Non-Concurrence Process Record for NCP-2013-013

NCP TRACKING NUMBER
NCP-2013-013

TITLE OF SUBJECT DOCUMENT Staff Evaluation and Recommendation for Japan Lessons-Learned Tier 3 Issue on Expedited Transfer of		ADAMS ACCESSION NO. ML13256A348
DOCUMENT SIGNER Michael R. Johnson		SIGNER PHONE NO. (301) 415-1713
TITLE Deputy Executive Director for Reactors and Preparedness Progra	ORGANIZATION EDO	
NAME OF NON-CONCURRING INDIVIDUAL(S) Brian Wagner		PHONE NO. (301) 251-7595
TITLE Reliability and Risk Engineer	ORGANIZATION RES/DRA/PRB

Comparison of Results for Mark I/IIs

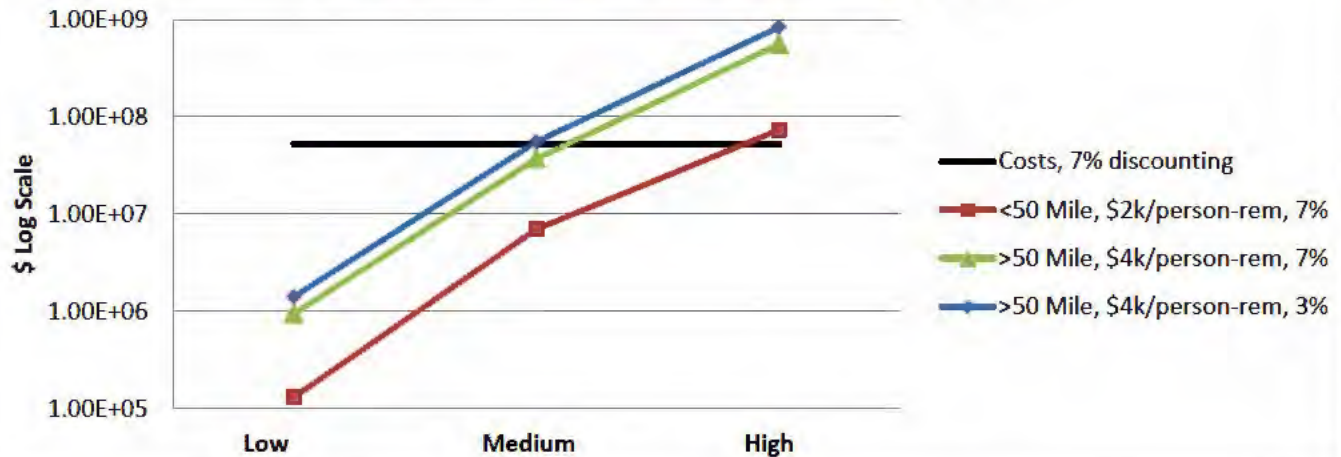
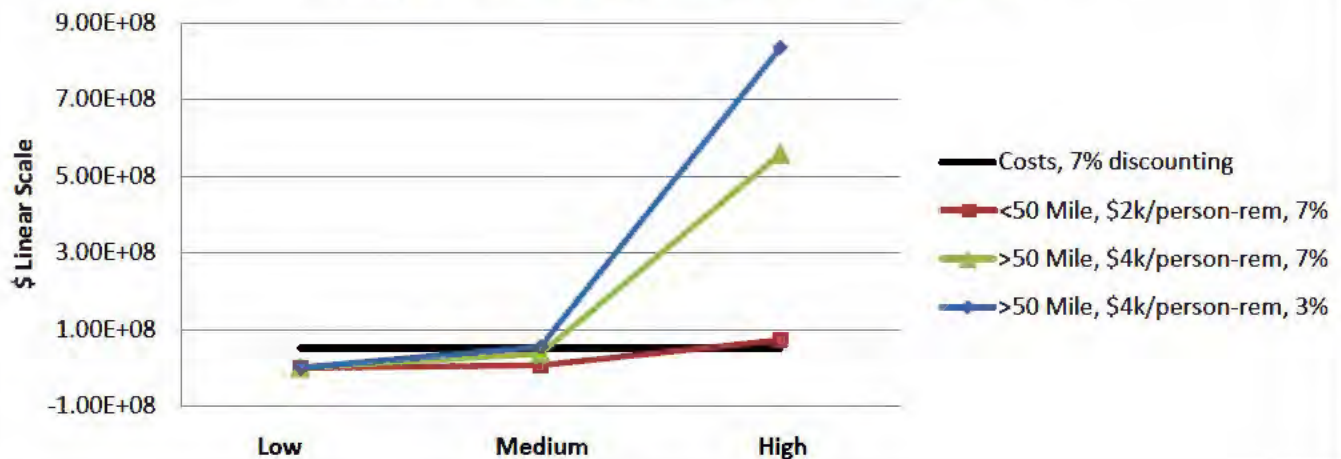
I have produced several figures and tables below to illustrate the results of the regulatory analysis. They paint a much muddier picture as to whether or not the alternative is cost-beneficial when compared to the COMSECY.

Group 1		Costs, 7% discounting	<50 Mile, \$2k/person- rem, 7%	>50 Mile, \$4k/person- rem, 7%	>50 Mile, \$4k/person- rem, 3%
Low Estimate	1	5.23E+07	1.31E+05	9.47E+05	1.42E+06
Medium Estimate	2	5.23E+07	7.01E+06	3.71E+07	5.54E+07
High Estimate	3	5.23E+07	7.31E+07	5.59E+08	8.35E+08

Costs are relatively insensitive to discounting.

Comparison of Results for PWR and BWR Mark IIIs

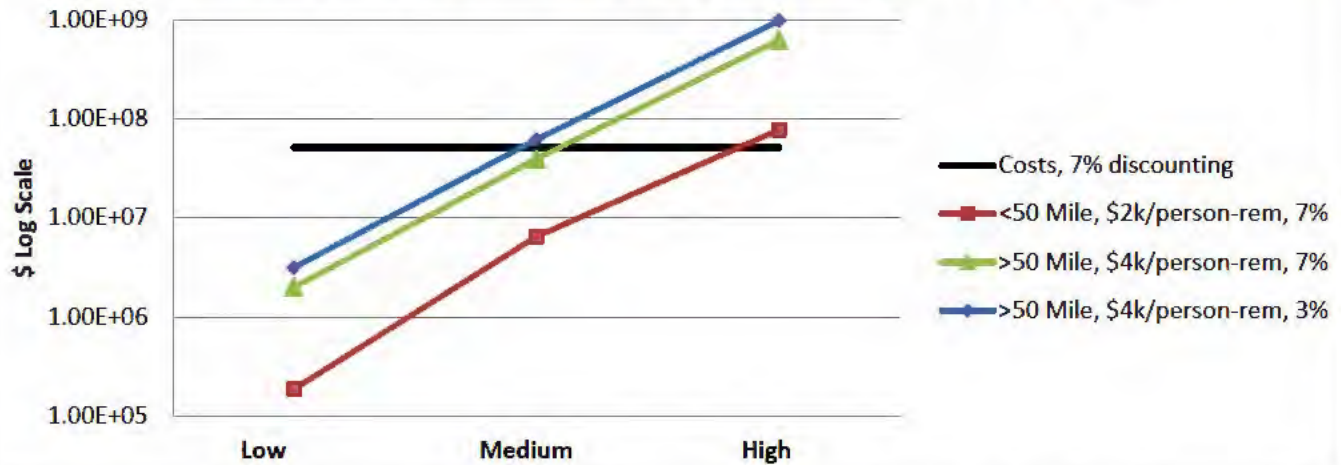
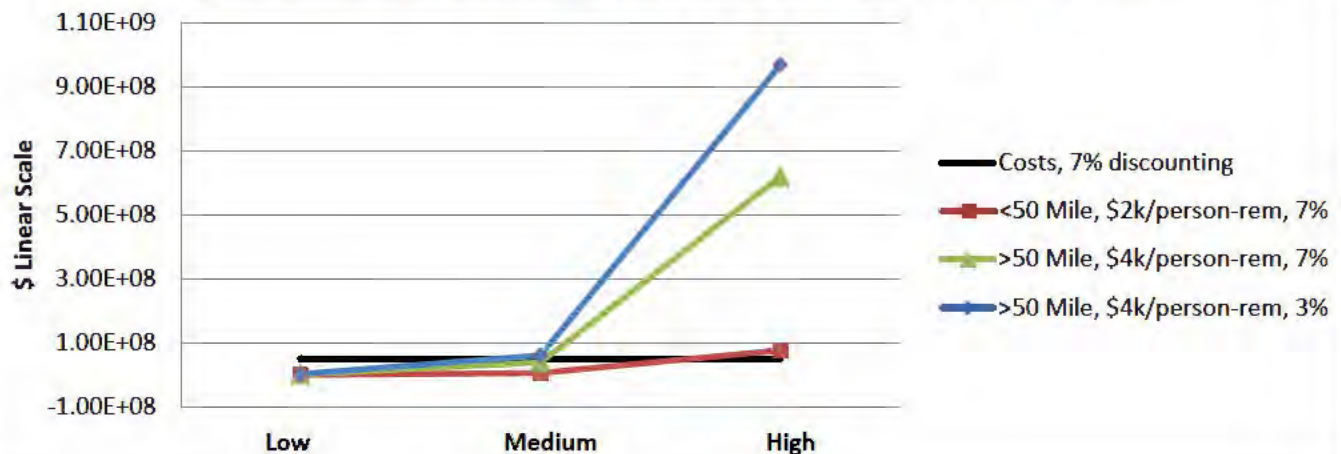
Group 2		Costs, 7% discounting	<50 Mile, \$2k/person- rem, 7%	>50 Mile, \$4k/person- rem, 7%	>50 Mile, \$4k/person- rem, 3%
Low Estimate	1	5.14E+07	1.88E+05	2.02E+06	3.15E+06
Medium Estimate	2	5.14E+07	6.48E+06	3.94E+07	6.16E+07
High Estimate	3	5.14E+07	7.70E+07	6.21E+08	9.70E+08

Costs are relatively insensitive to discounting.

Comparison of Results for New Rxs non-shared Pools

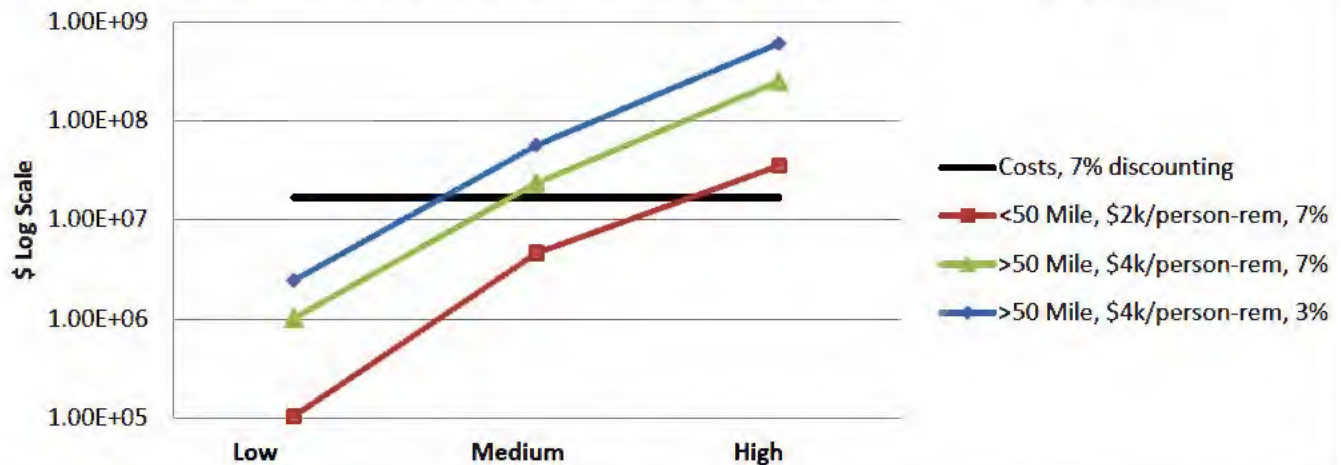
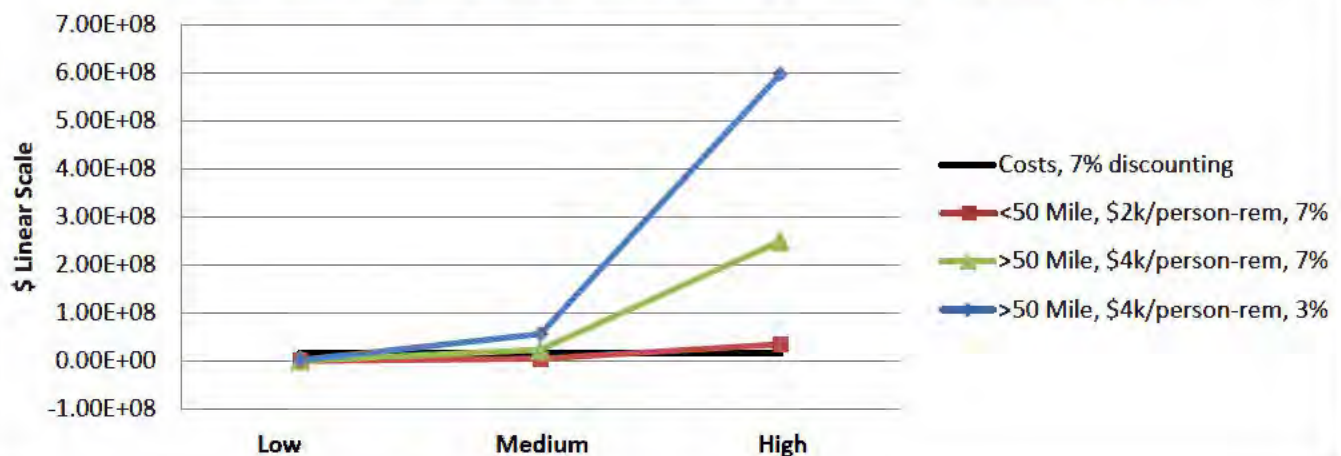
Group 3		Costs, 7% discounting	<50 Mile, \$2k/person- rem, 7%	>50 Mile, \$4k/person- rem, 7%	>50 Mile, \$4k/person- rem, 3%
Low Estimate	1	1.68E+07	1.05E+05	1.02E+06	2.45E+06
Medium Estimate	2	1.68E+07	4.63E+06	2.35E+07	5.64E+07
High Estimate	3	1.68E+07	3.49E+07	2.50E+08	5.98E+08

Note that for group 3 discounting costs at 3% would increase them by a factor of ~2. Not reflected in the graph.

Comparison of Results for Shared Pools

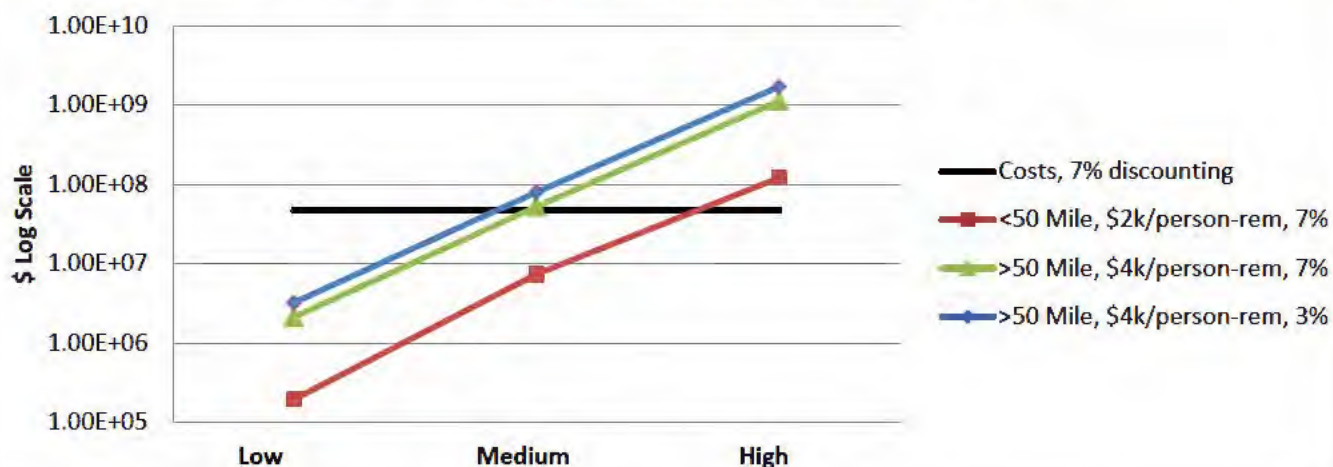
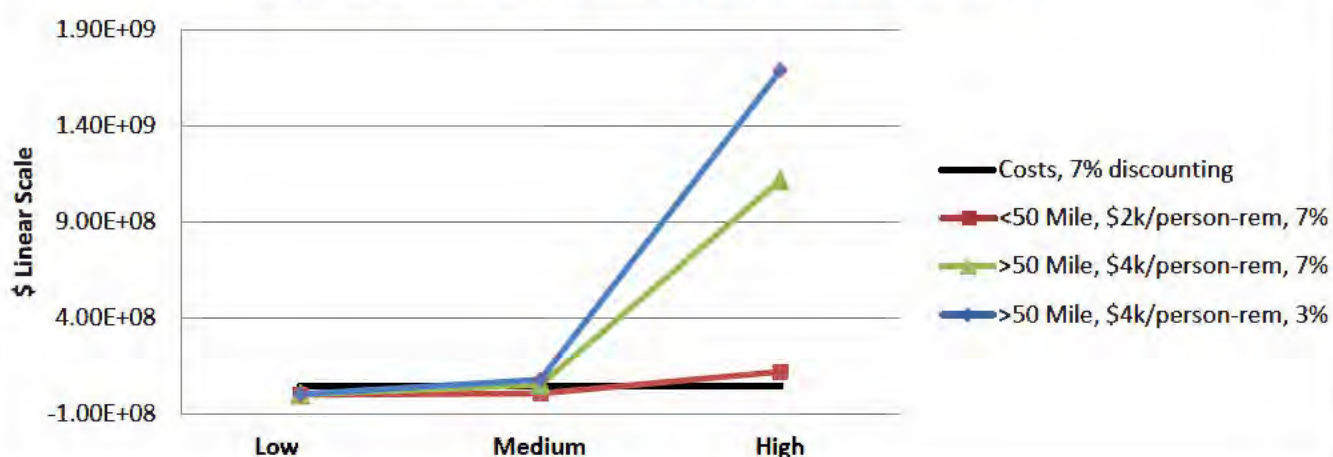
Group 4		Costs, 7% discounting	<50 Mile, \$2k/person- rem, 7%	>50 Mile, \$4k/person- rem, 7%	>50 Mile, \$4k/person- rem, 3%
Low Estimate	1	4.64E+07	1.95E+05	2.12E+06	3.21E+06
Medium Estimate	2	4.64E+07	7.33E+06	5.22E+07	7.89E+07
High Estimate	3	4.64E+07	1.20E+08	1.12E+09	1.69E+09

Costs are relatively insensitive to discounting.
